### **HISTORIC DISTRICT REVIEW BOARD**

Wednesday, September 9, 2020, 2:00 P.M.

B. 1307 Bay Street, Addition

A. 809 Port Republic Street, New Construction

Updated Wall Section

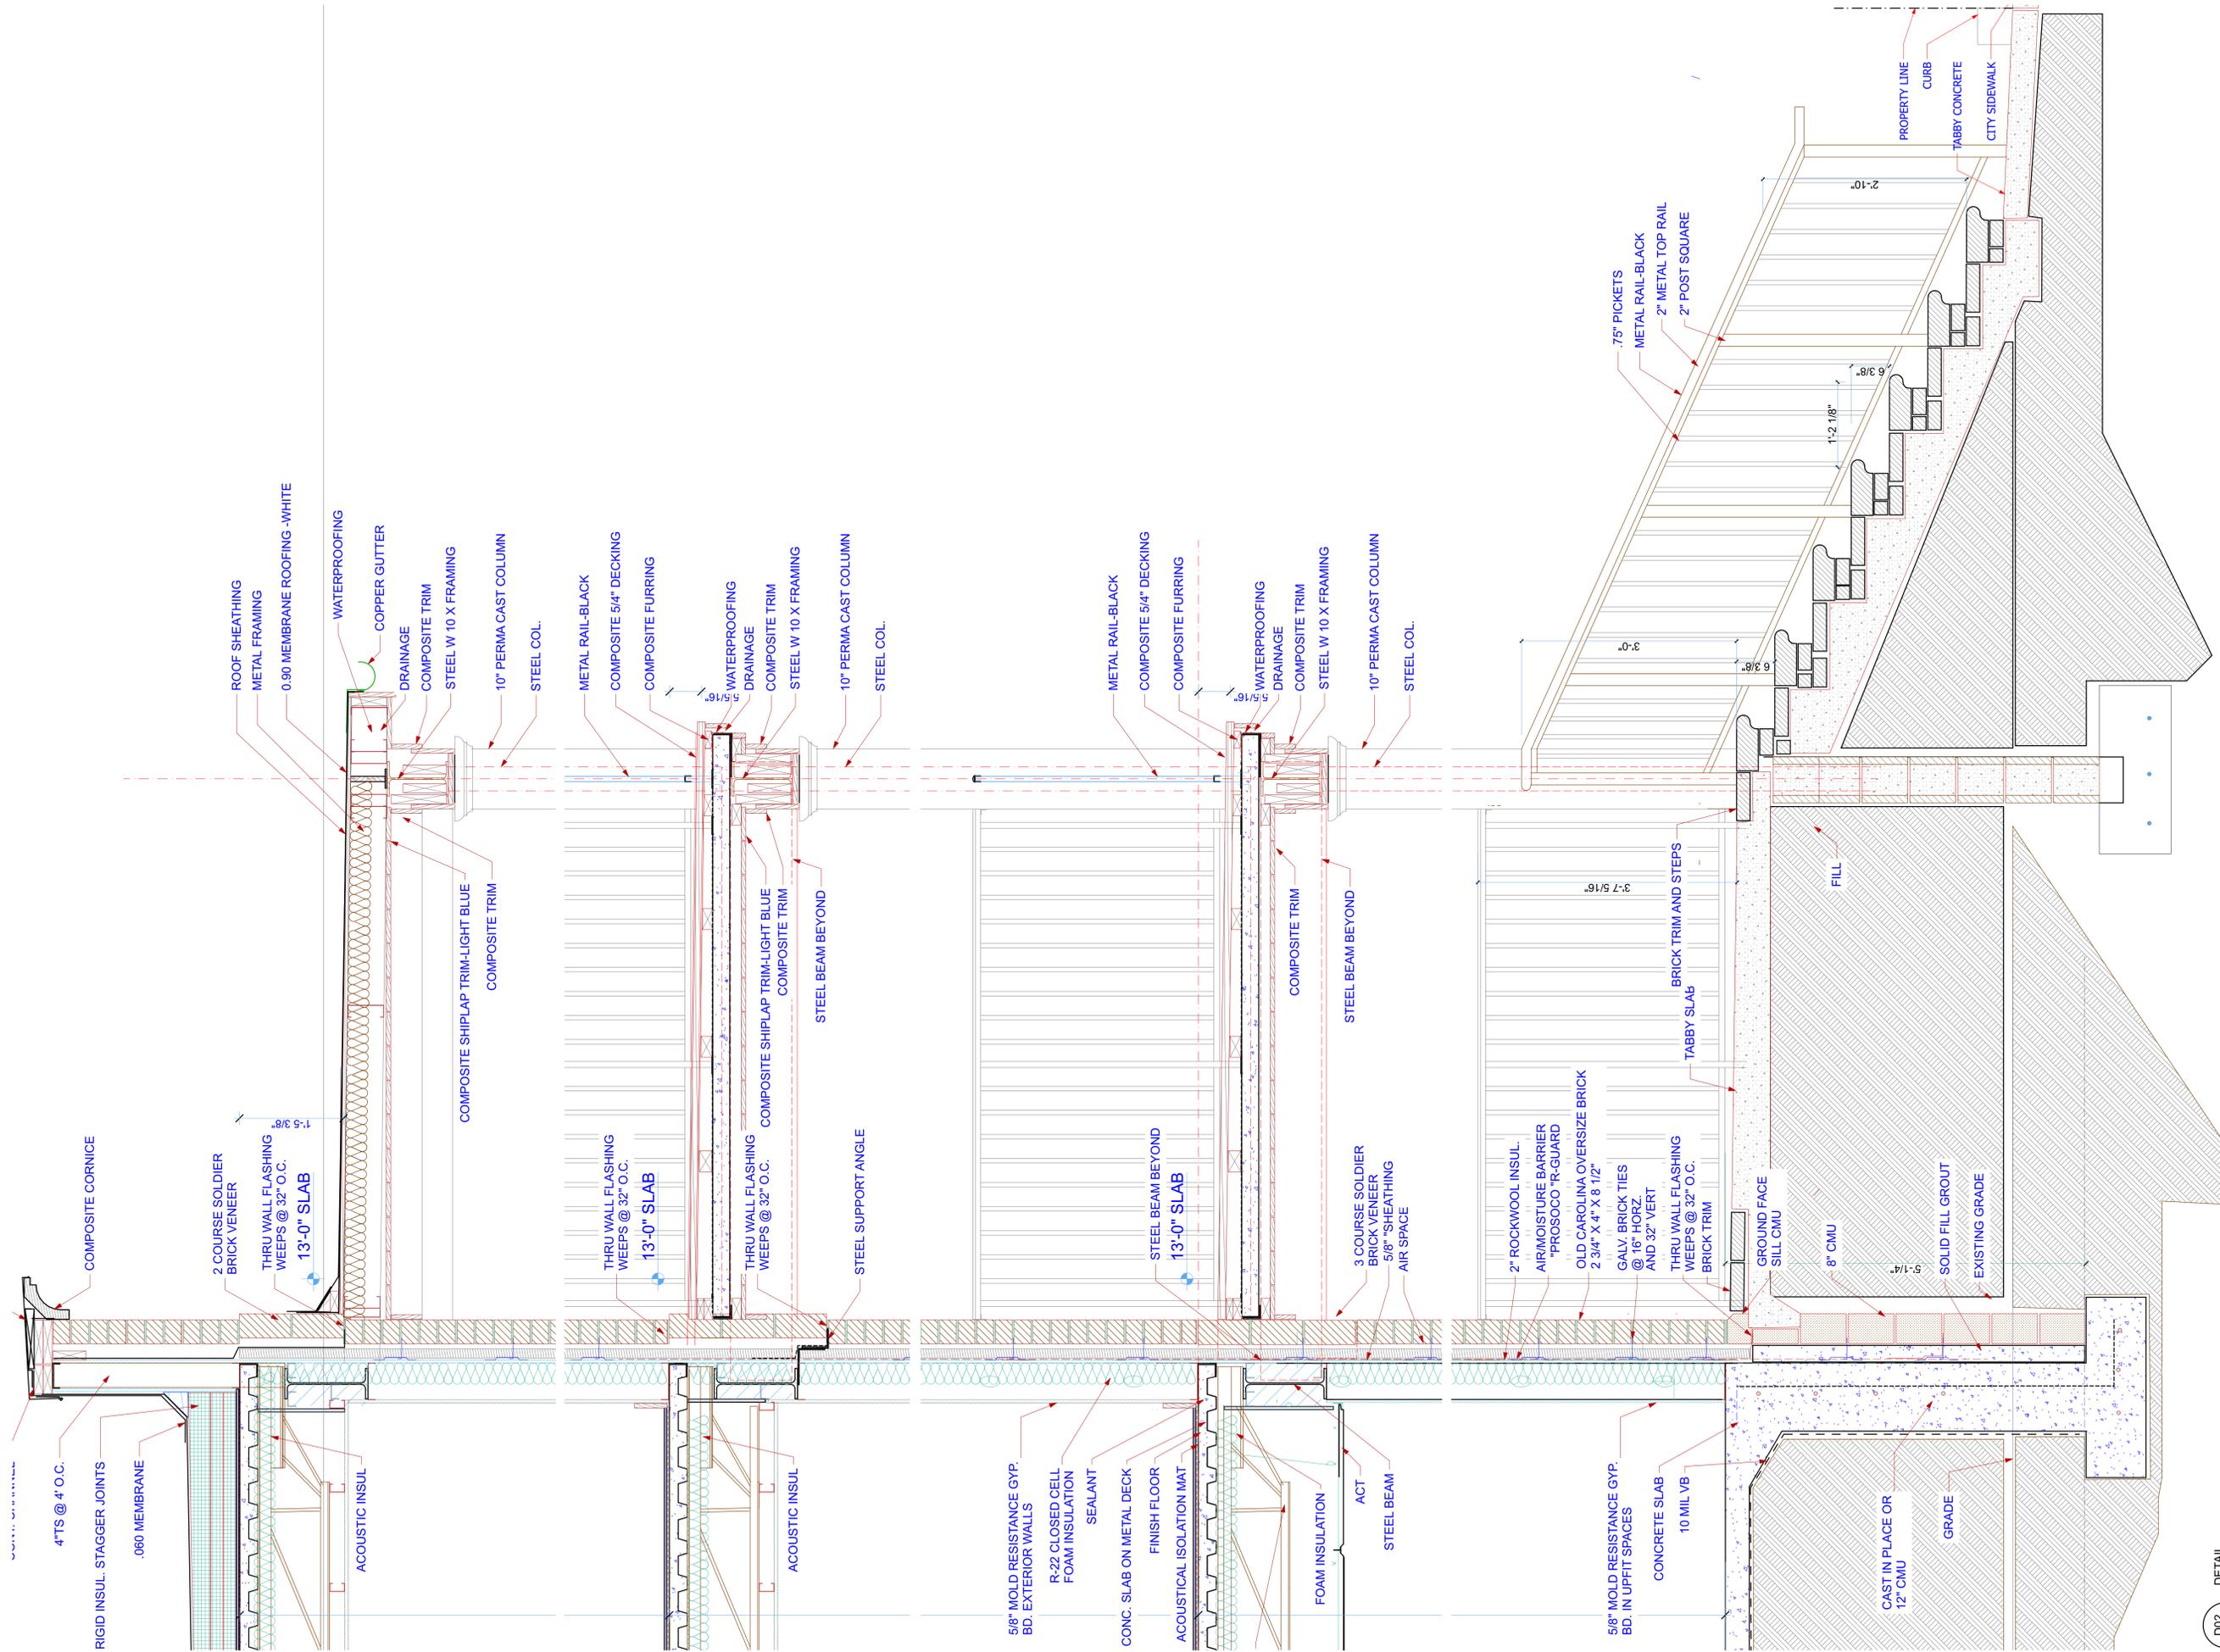
4. For Final Review (in addition to the above requirements for conceptual review):
  - A typical wall section has been provided that portrays a brick wall, but the 3d views and elevation indicate that several typical wall conditions exist. Please include a typical wall section for each typical wall condition. Please also include typical details for all porch conditions (single and multi-story), for canopies, ramp, railings, stairs, parapets, and all window conditions. **new detail is added showing porch conditions and porch roof condition.**
